ADuCM320/ ADuCM320i ADuCM322/ADuCM322i PCN

11/30/2018

Details on Silicon Change

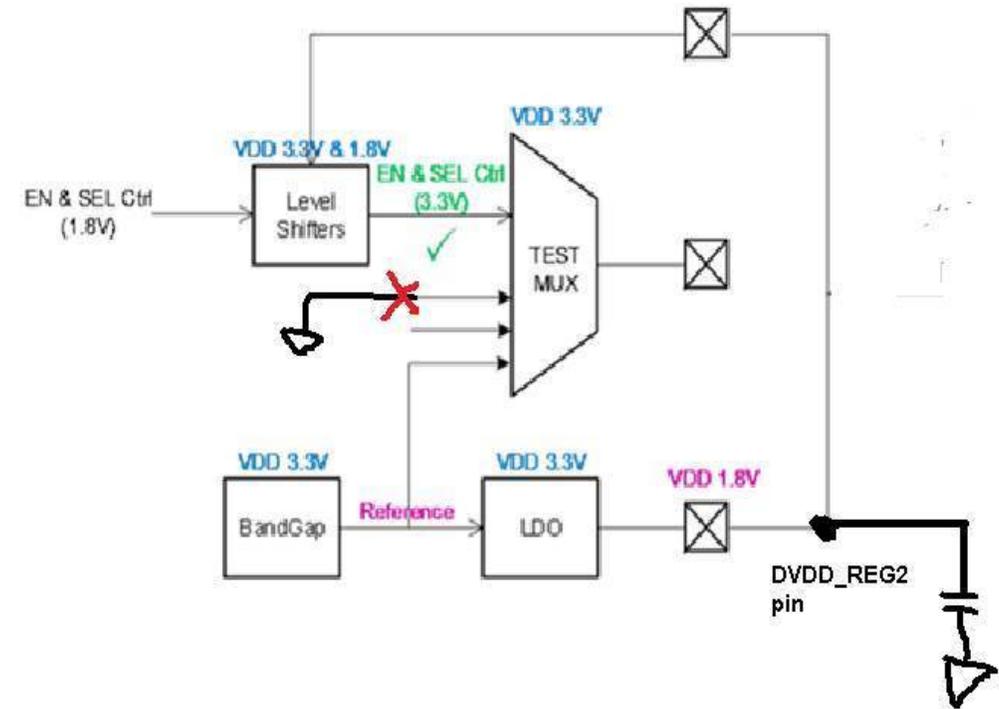
- ▶ Cut a single track to disconnect a grounded input to a Test Mux – see the red “x” below to indicate the location.
- ▶ When the 3.3V DVDD power supply is rising from 0V towards the Power-On reset threshold voltage, the enable and select signals to the Test MUX shown below are undefined.
- ▶ In some corner cases on previous silicon, this sometimes resulted in the output of the Bandgap being shorted to the GND input of the MUX.
- ▶ This meant that the digital LDO did not get a valid bandgap voltage and did not power up correctly.
- ▶ The digital LDO output is 1.8V and is required for the Cortex-M3 and other digital peripherals to operate properly.
- ▶ In the failing cases, this 1.8V rail did not come up properly and led to the Cortex-M3 never executing user code
